■ 3RZ-FE ENGINE

1. General

258CO02

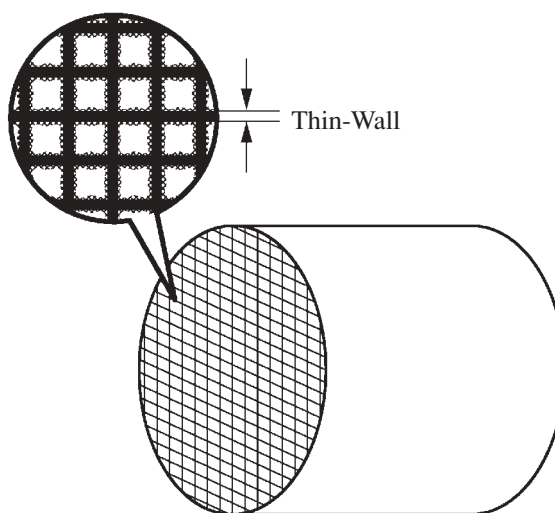
- The engine has been changed to the unleaded gasoline type.
- A thin-wall, ceramic type TWC has been adopted.
- One oxygen sensor has been newly provided in front of the TWC in order to improve the exhaust reduction performance of the TWC through feedback control to the engine ECU.
